ADDENDUM NO. 1

POLICE FACILITY LOCKER ROOM IMPROVEMENTS PROJECT

BID NO. RFB-19-350-13

DATE OF ADDENDUM: JULY 22, 2019

SK-1
PHASE 1
SCALE: 1/8" = 1'-0"

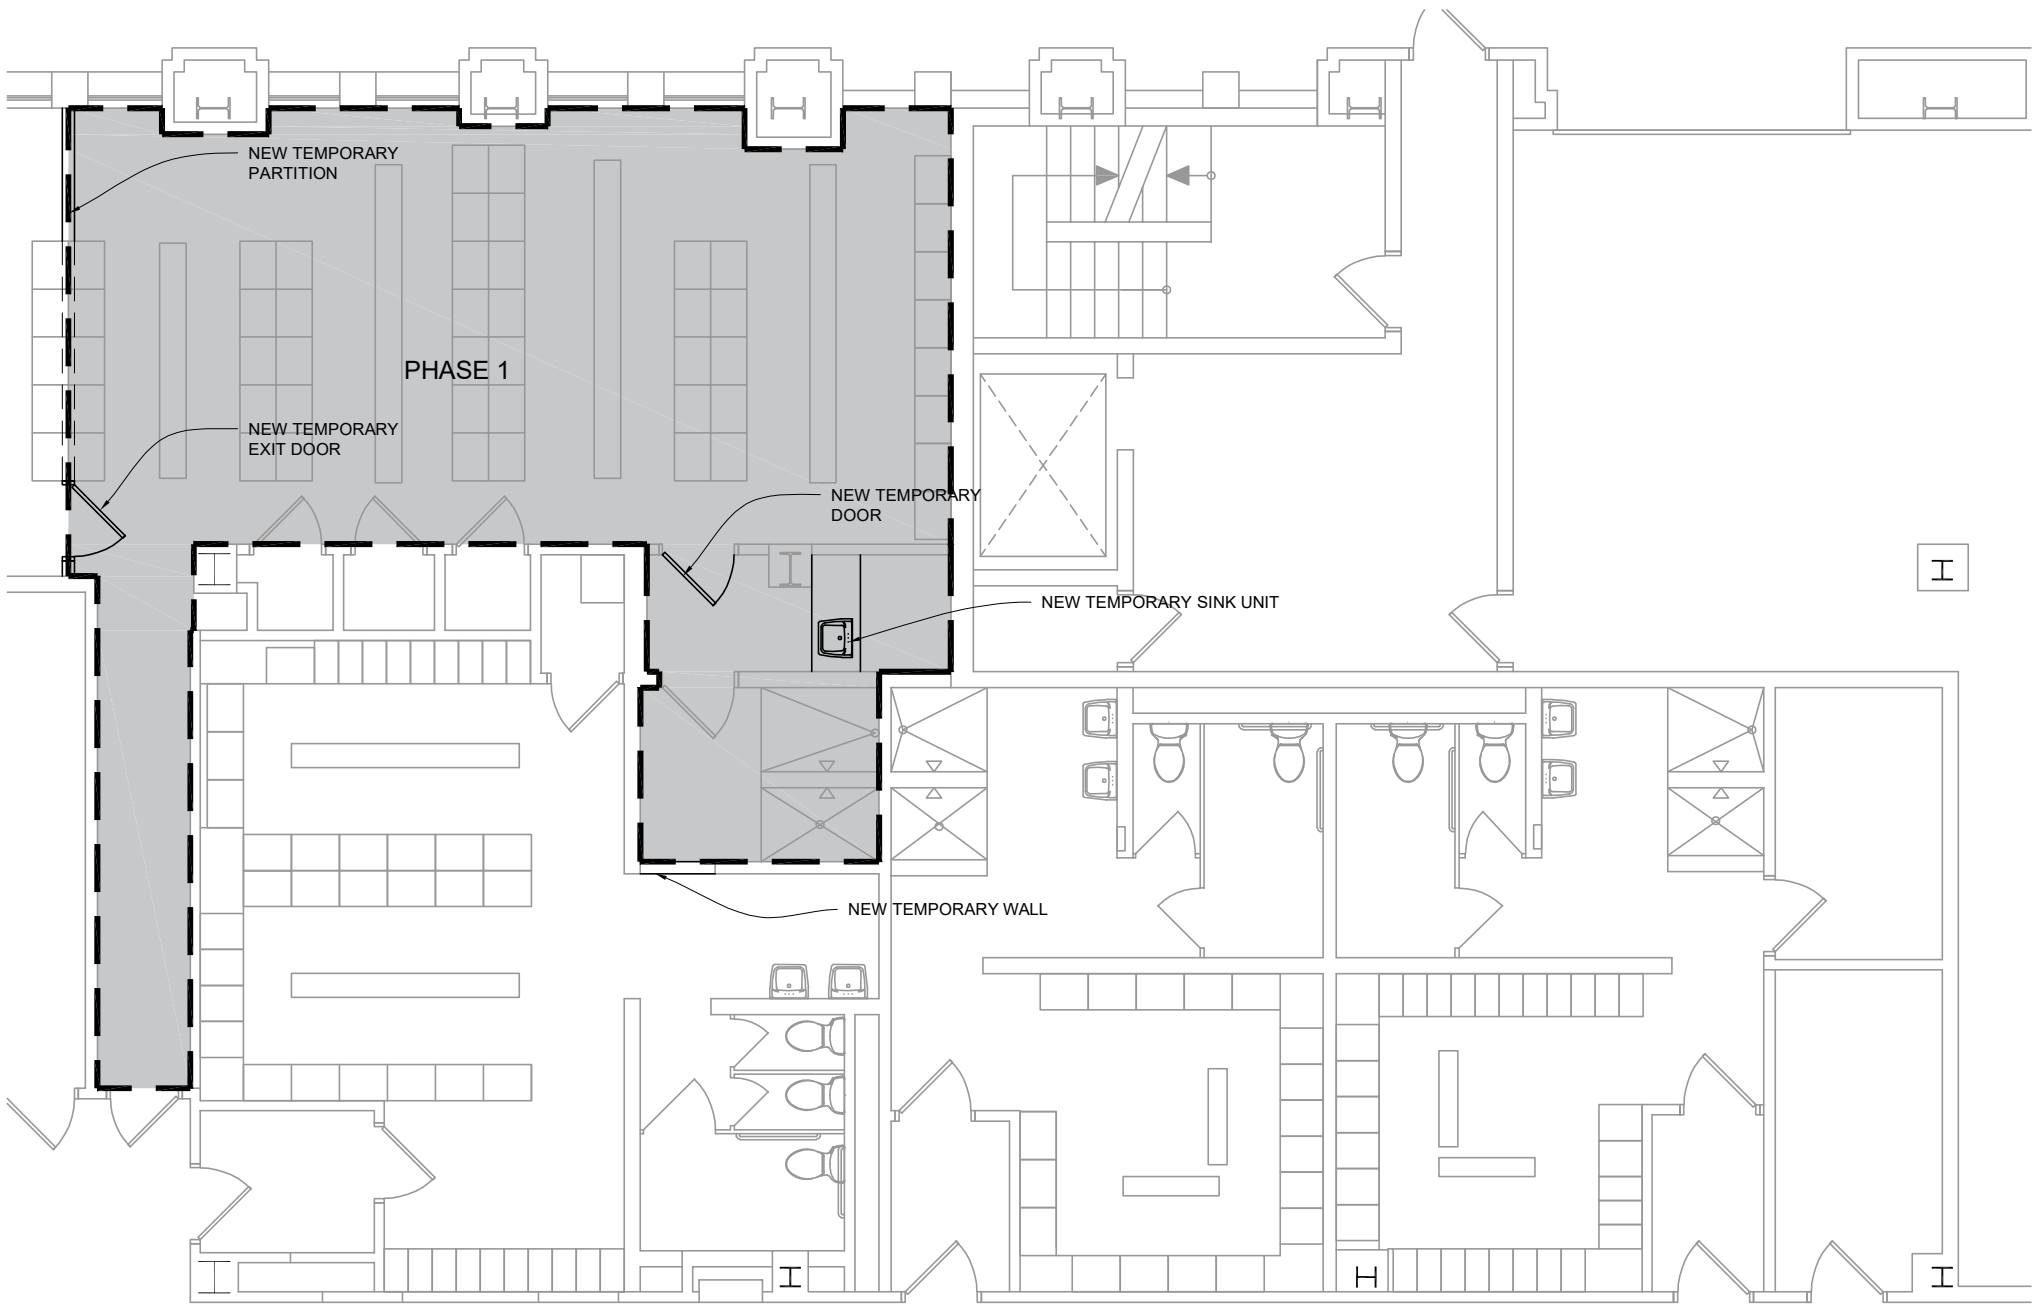
Refer to Appendix 1: Scope of Work, Paragraph 1.2 PHASING. Provide an Add Alternate cost and extension of time required to implement Phasing of the Work in 3 Phases as described in the attached SK-1 and SK-2.

In order to keep access to female shower areas, the proposed janitor room and the two southern showers shall be done as phase 2 after the rest of the area is completed. The contractor shall construct a temporary wall on the east side of these shower area. Refer to attached Exhibit 'A'.

SK-3

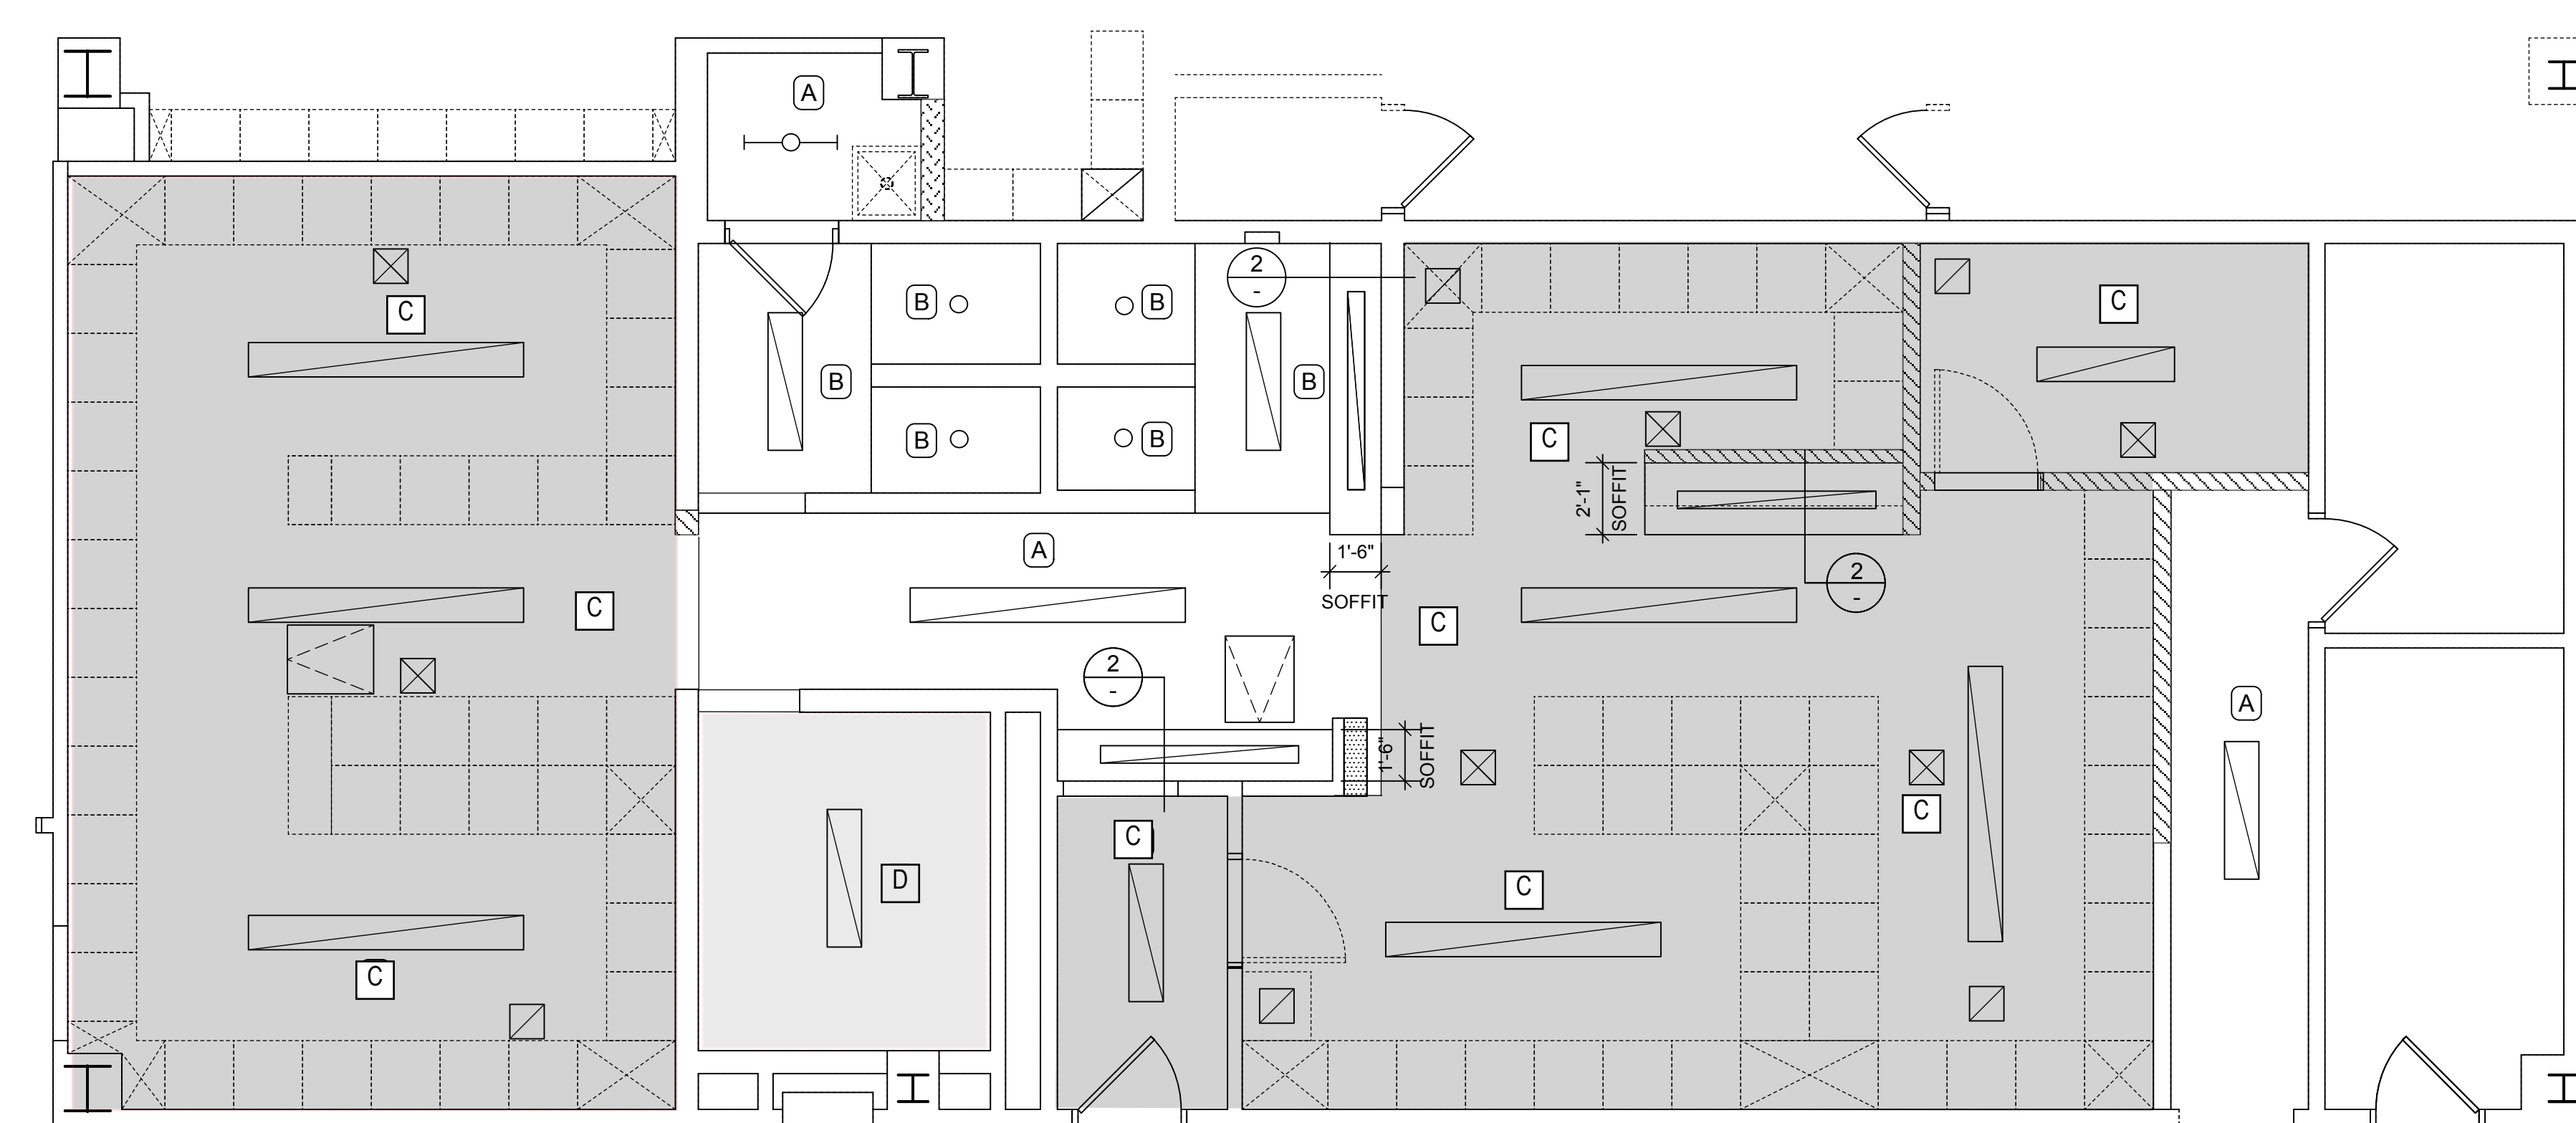
Refer to A-2.00 Reflected Ceiling Plan. Provide as part of Base Bid revised ceiling finishes as indicated on SK-3.
